Access Compliance Report

Public Rights-of-Way

(Curb Ramps)

Intersection ID: 27582	Main Street: BALLANTYNE COUNTRY CLUB DR	Cross Street: LEDERER AV	Location: NW
ADA ID: 84605EDDDA53	Ramp Type: BlendTrans2	Initial Pass/Fail: Fail	Overall Compliance: No
Severity Score: 12.5			
Codes/Mitigation Info/Possible Solution		Field Measurements/Component Compliance

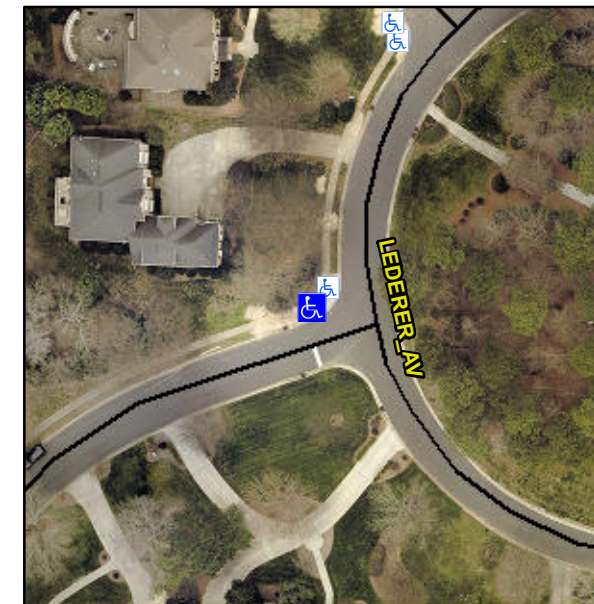
Not Found, R304.5.3

Compliance	Description	Data	Compliance	Description	Data
N/A	Ramp Length (in)	99.0	Yes	BlendTrans Slope (%)	0.0
Yes	Ramp Width (in)	48.0	No	BlendTrans XSlope (%)	6.3
N/A	Flare Type LT	N/A	N/A	Flare Type RT	N/A
N/A	Flare Slope LT (%)	N/A	N/A	Flare Slope RT (%)	N/A
N/A	Flare Traversable LT?	N/A	N/A	Flare Traversable RT?	N/A
N/A	Landing Length (in)	N/A	N/A	DWS Provided?	N/A
N/A	Landing Width (in)	N/A	N/A	DWS Contrast?	N/A
N/A	Landing Slope (%)	N/A	N/A	DWS Length (in)	N/A
N/A	Landing X Slope (%)	N/A	N/A	DWS Full Width?	N/A
N/A	Landing Curb? (Y/N)	N/A	N/A	DWS Offset (in)	N/A
N/A	Shared Landing?	N/A			
N/A	Gutter Ponding?	N/A	N/A	Gutter Slope (%)	N/A
N/A	Gutter Lip Ht (in)	N/A	N/A	Gutter X Slope (%)	N/A
N/A	Painted X Walk1?	No	N/A	Painted X Walk2?	N/A
	X Walk 1 Direction	To SE		X Walk 2 Direction	N/A
	X Walk 1 Width (in)	N/A		X Walk 2 Width (in)	N/A
	X Walk 1 Slope (%)	4.0		X Walk 2 Slope (%)	N/A
	X Walk 1 X Slope (%)	4.2		X Walk 2 X Slope (%)	N/A

N/A	Ramp inside XWalk1?	N/A	N/A	Ramp inside XWalk2?	N/A
	Road Slope (%)	4.2		Clear Space?	N/A
	Road X Slope (%)	4.0	N/A	Clear Space to XWalk (in)	N/A
N/A	Any Obstructions?	N/A	N/A	Storm Grate/Utility Hazard?	N/A
	Obstruction Type			Storm Grate/Utility Type	
		N/A			N/A
			Yes	Surface Condition? (G/P)	Good
			No	Curb Slope (%)	14.8

Remove & Replace Curb Ramp With Two New Directional Ramps or Equivalent.
